Re: Draft Environmental Impact Statement: Update of the Water Control Manual for the Apalachicola-Chattahoochee-Flint River Basin in Alabama, Florida, and Georgia and a Water Supply Storage Assessment (Oct. 2015)

Thank you for the opportunity to comment on the Draft Environmental Impact Statement: Update of the Water Control Manual for the Apalachicola-Chattahoochee-Flint River Basin in Alabama, Florida, and Georgia and a Water Supply Storage Assessment (Oct. 2015) (the "Draft EIS"). These comments are submitted on behalf of the water supply providers in the metropolitan Atlanta region including: the Atlanta Regional Commission; the City of Atlanta; the Atlanta-Fulton County Water Resources Commission; the Cobb County-Marietta Water Authority; DeKalb County; Forsyth County; Fulton County; Gwinnett County; and, the City of Gainesville (collectively, the "Water Supply Providers").

**Figure 14. Chattahoochee Gage Flows:
Army PAA vs. Zone 4 Drought Contingency Operations**

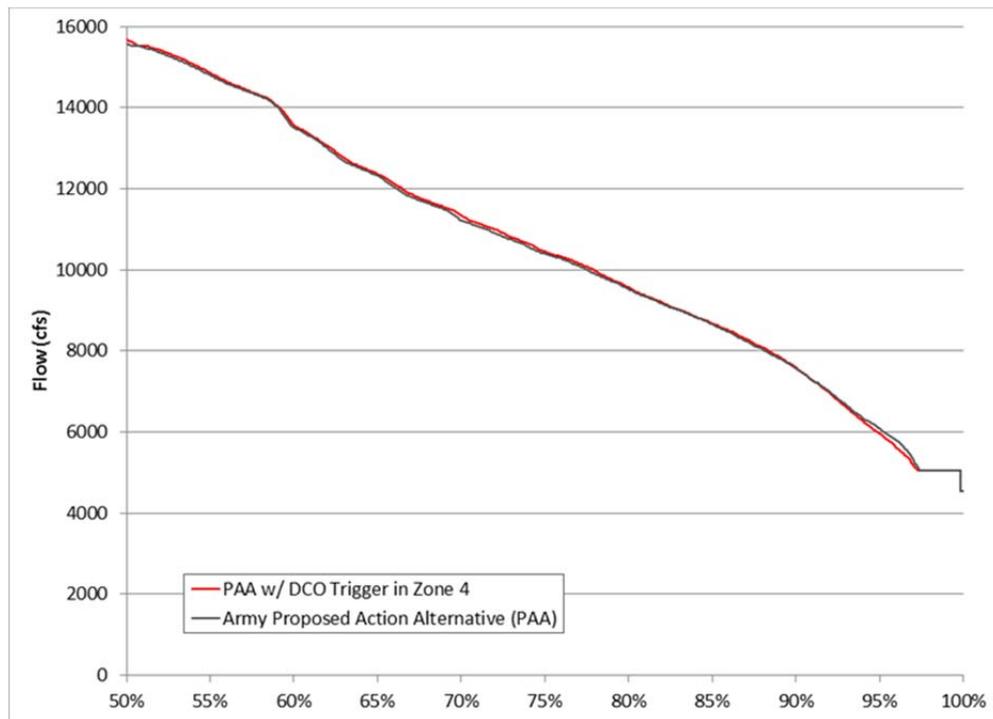
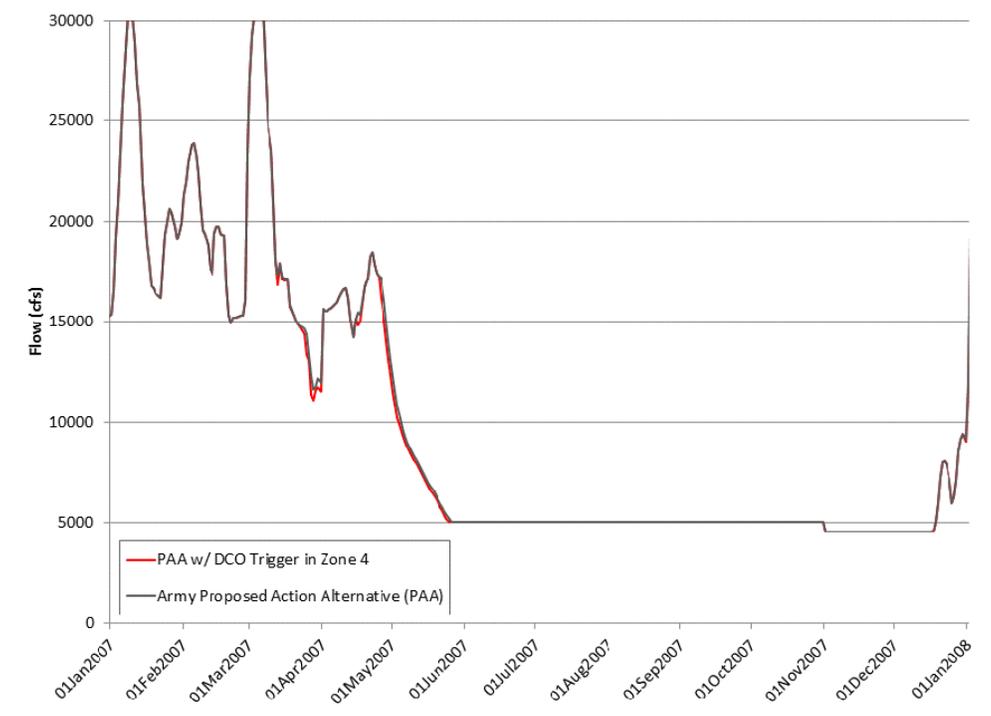
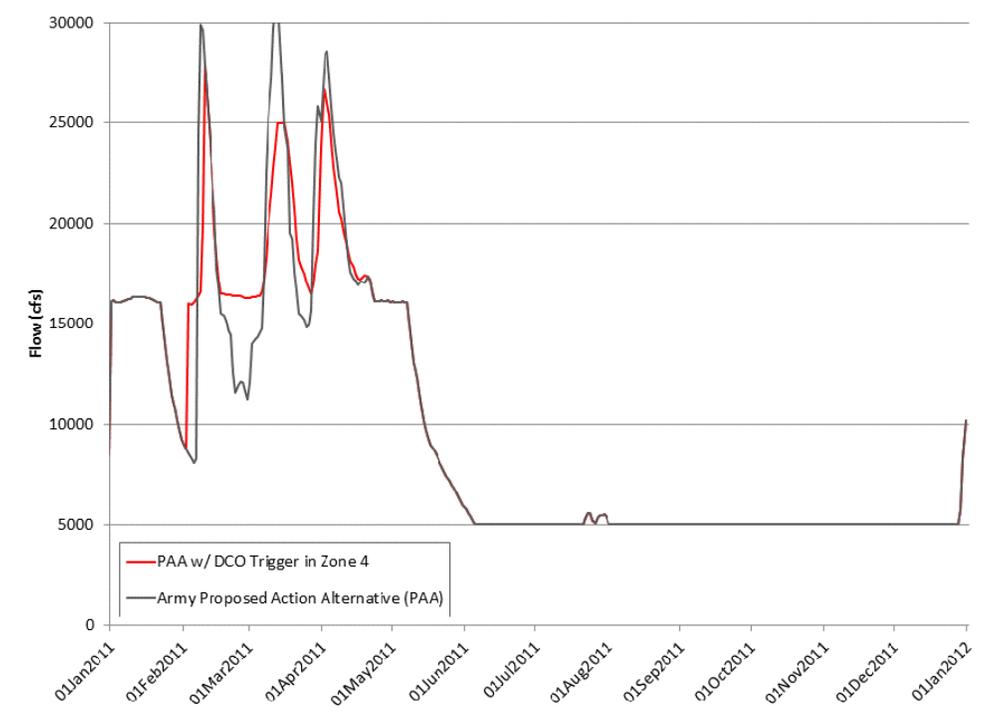
The PAA also changes the threshold at which drought contingency operations begin from Composite Storage Zone 4 to Composite Storage Zone 3. This change allows the Army to respond to drought conditions sooner, before the system reaches critical levels. The additional storage reserve early in a drought, especially in Lake Lanier, which does not refill during multi-year droughts, provides critical provisions during severe drought. Such reserves become all the more essential when accounting for possible future hydrologic conditions that may be different from those experienced in the hydrologic record.

Entering drought contingency operations sooner does not necessarily mean that flows will be lower over the long term. Additional savings early in a drought can cause the system to recover sooner, allowing flows to return to normal levels earlier. Flow frequency curves for the PAA and the PAA with drought operations triggered in Zone 4 are shown in Figure 14. Over the full period of record (1939-2011) there is no difference in the flows. Similarly, there is no appreciable difference in the timing of flows under droughts (Figure 15, Figure 16, showing flows at the Chattahoochee gage when drought operations are commenced in Zone 3).

This analysis also demonstrates that using drought operations, either the amount of time in drought operations or number of times triggered, as is done in Chapter 6 (see Table 6.1-11) can be misleading and is certainly not a good surrogate for flows. For the two scenarios shown above—the PAA and the PAA with drought operations triggered in Zone 4—the flows are not significantly different but the drought operations measures are: the PAA is in drought operations 18% of the time, compared to 10% for the PAA with Zone 4 trigger; drought operations are triggered 22 times in the PAA, compared to 8 times in the PAA with Zone 4 trigger.
